HISTORIC AND DESIGN REVIEW COMMISSION

March 06, 2019

HDRC CASE NO: 2019-078
ADDRESS: 124 GLORIETTA
LEGAL DESCRIPTION: NCB 576 BLK 15B LOT E 56.45 FT OF 5
ZONING: RM-4, H
CITY COUNCIL DIST.: 2
DISTRICT: Dignowity Hill Historic District
APPLICANT: Edward Casias
OWNER: Andres Casias
TYPE OF WORK: Window Replacement; removal of siding; side deck
APPLICATION RECEIVED: February 15, 2019
60-DAY REVIEW: April 14, 2019

Proposed Work at 124 GLORIETTA

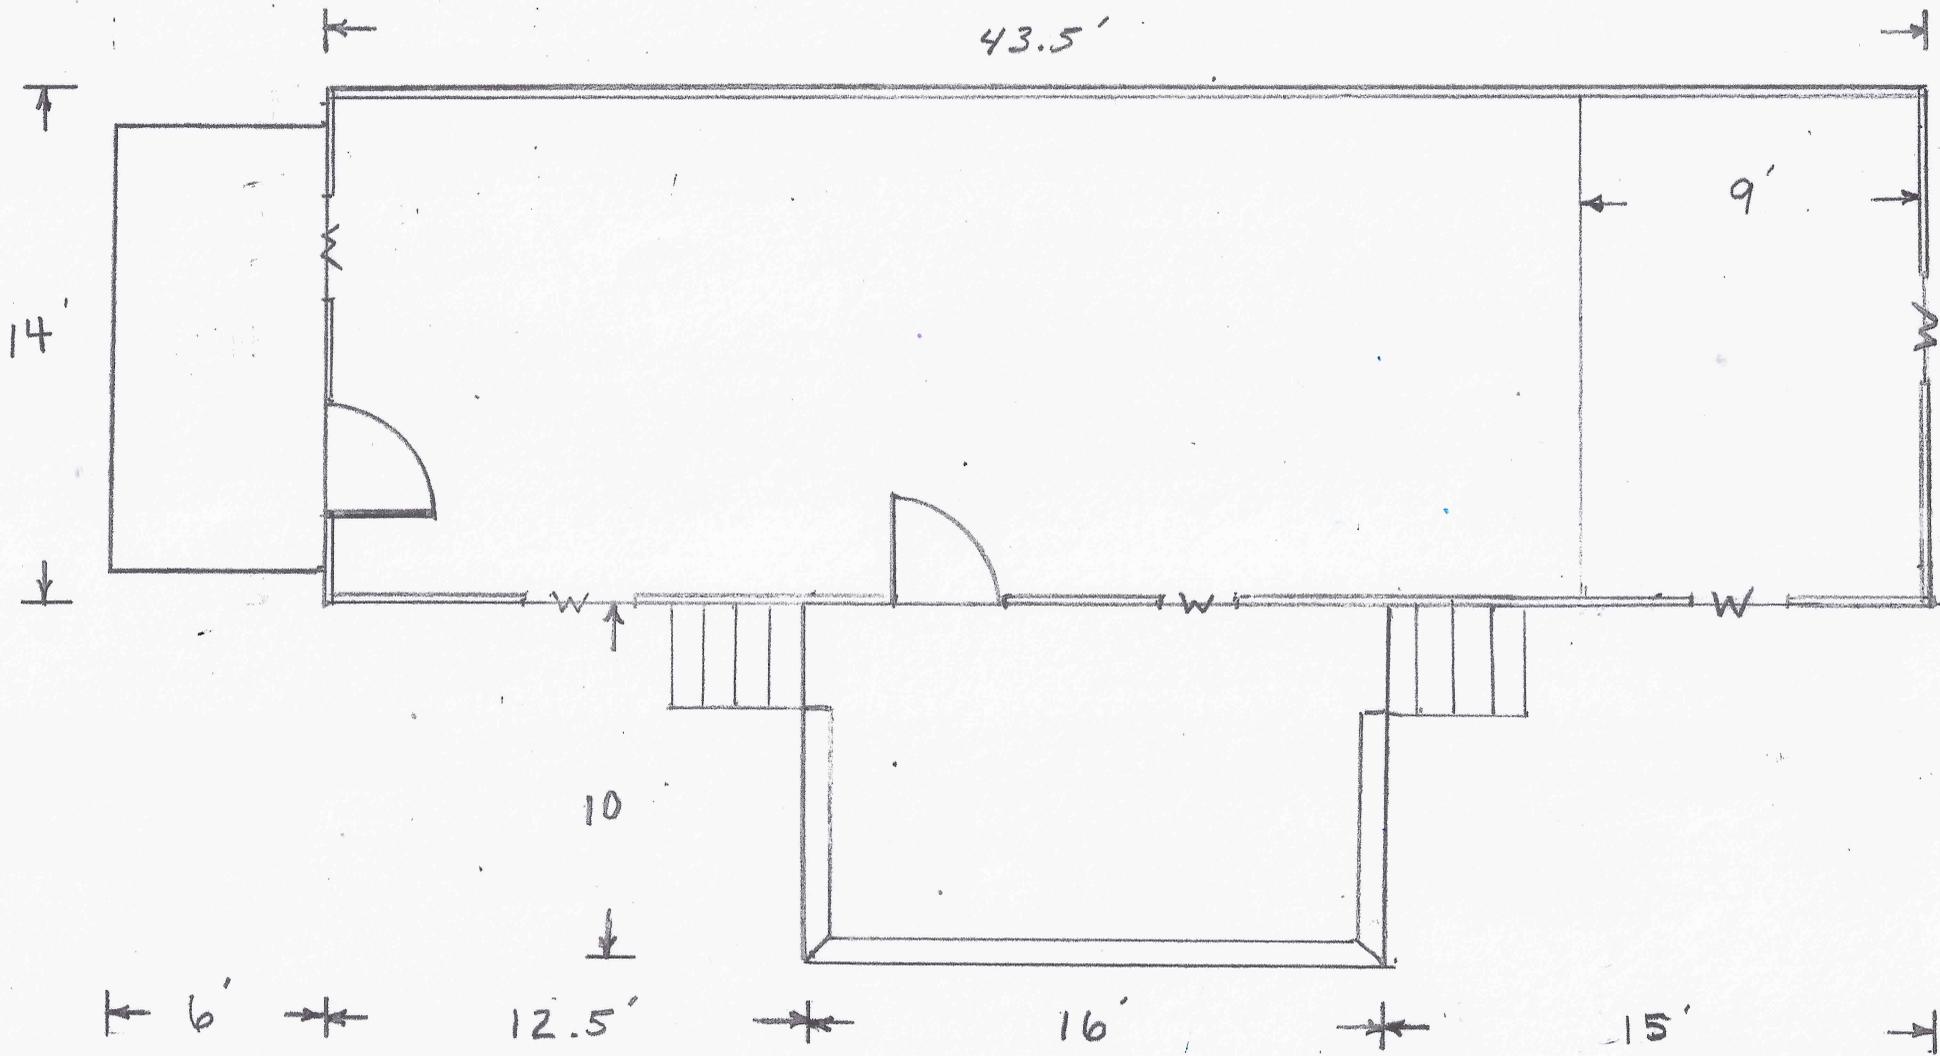
- c. SIDE PORCH – The applicant has proposed to a 160 square foot (10' x 16') wood deck on the west elevation of the structure including a new door opening. The proposed deck features vertical lap skirting, 2" x 6" wood decking, cattle panel fencing as railing, and front and rear wood steps. Per the Guidelines for Exterior Maintenance and Alterations 7.A.i, new porches should not be added where not historically present. Staff finds that side porches were not found on shotgun houses and adding a porch would detract from the character-defining linear configuration of the historic structure. Additionally, staff finds that the design of the porch, regardless of location, is a departure from a porch that is typically found in the historic district; cattle panel fencing should not be used at railing and skirting should feature horizontal lap siding instead of vertical configuration. The side porch should be removed including the new door opening.

- d. REAR ADDITION – The applicant has proposed to construct a 126 square foot (9' x 14') rear addition featuring a corrugated metal shed roof, vertical metal siding, and vinyl clad windows. The proposed addition is generally consistent with the Guidelines for Additions by 1) being subordinate to the historic structure in height and footprint while maintaining the linear configuration 2) featuring materials that relates to the historic structure's metal roof, 3) providing a visual distinction between new and old forms by a change in siding material, and 4) relates architectural details back to the historic structure including the shed roof and the sashed windows.

- e. WINDOW REPLACEMENT – The applicant has proposed to replace 4 windows: 1 front wood sashed window to be replaced with wood casement window and 3 west elevation windows with vinyl clad wood windows. Per the Guidelines for Exterior Maintenance and Alterations 6.B.iv., new windows should match the historic or existing windows in terms of size, type, configuration, material, form, appearance, and detail when original windows are deteriorated beyond repair. Staff finds that the proposed windows are not consistent with the Guidelines and that new replacement windows should feature the standard specifications: *Meeting rails that are no taller than 1.25" and stiles no wider than 2.25". White manufacturer's color is not allowed, and color selection must be presented to staff. There should be a minimum of two inches in depth between the front face of the window trim and the front face of the top window sash. This must be accomplished by recessing the window sufficiently within the opening or with the installation of additional window trim to add thickness. Window trim must feature traditional dimensions and an architecturally appropriate sill detail. Window track components must be painted to match the window trim or concealed by a wood window screen set within the opening.*

- f. WINDOW REMOVAL – The applicant has proposed to remove two window openings on the east side elevation and infill with siding. Per the Guidelines for Exterior Maintenance and Alterations 6.A.i., historic window openings should be preserved and not infilled. Staff finds that the window openings should be restored to their original location and size and feature a matching wood sashed window.

- g. DOOR REPLACEMENT – The applicant has proposed to replace the front door with a metal-clad wood door with an ornamental glazing. Per the Guidelines for Exterior Maintenance and Alterations 6.B.i, new doors should be replaced in-kind when possible and when deteriorated beyond repair; when in-kind replacement is not feasible, ensure features match the size, material, and profile of the historic element. Staff finds that the proposed door is inconsistent with the Guidelines and should instead feature a 6-panel wood door.

- h. SIDING – The applicant has proposed to remove the wood lap siding and install wood siding mimicking a board-and-batten configuration. Per the Guidelines for Exterior Modifications 1.B.ii., in-kind materials should be used when possible or materials similar in size, scale, and character when exterior woodwork is beyond repair; replacement siding should match the original pattern, including exposures; Hardie board and other cementitious materials are not recommended. Staff finds that the board-and-batten profile is a departure from shotgun house style and other primary historic structures within the district. The original wood lap siding should be restored in featuring an appropriate profile and exposure.

- i. PORCH COLUMNS – The applicant has proposed to replace the turned porch columns and pilasters typical to the shotgun houses and Folk Victorian structures within the district with square cedar posts. Per the Guidelines for Exterior Maintenance and Alterations 7.B.iii., replace in-kind porches, balconies, porte-cocheres, and related elements, such as ceilings, floors, and columns, when such features are deteriorated beyond repair. When in kind replacement is not feasible, the design should be compatible in scale, massing, and detail while materials should match in color, texture, dimensions, and finish. Staff finds that the proposed square wood columns are inappropriate and that the original columns should be restored to its turned column detail including the pilasters.

Staff recommends approval of item number 2) the rear addition, and item number 8) the front porch light as proposed based on findings c and i.

Staff recommends approval of item number 5) door replacement based on finding f with the stipulation that it features a simple wood 6-panel door instead of the proposed metal clad door with ornamental glazing.

Staff recommends approval of item number 3) window replacement if the original wood sashed windows have been permanently discarded based on findings d with the stipulation that new windows are constructed of wood or aluminum-clad wood with the standard specifications: *Meeting rails that are no taller than 1.25” and stiles no wider than 2.25”.* *White manufacturer’s color is not allowed, and color selection must be presented to staff. There should be a minimum of two inches in depth between the front face of the window trim and the front face of the top window sash. This must be accomplished by recessing the window sufficiently within the opening or with the installation of additional window trim to add thickness. Window trim must feature traditional dimensions and an architecturally appropriate sill detail. Window track components must be painted to match the window trim or concealed by a wood window screen set within the opening.*

Staff does not recommend approval of items number 1) the construction of a side porch, item number 4) window opening removal, item number 6) the installation of board-and-batten siding, and item number 7) column replacement and pilaster removal.
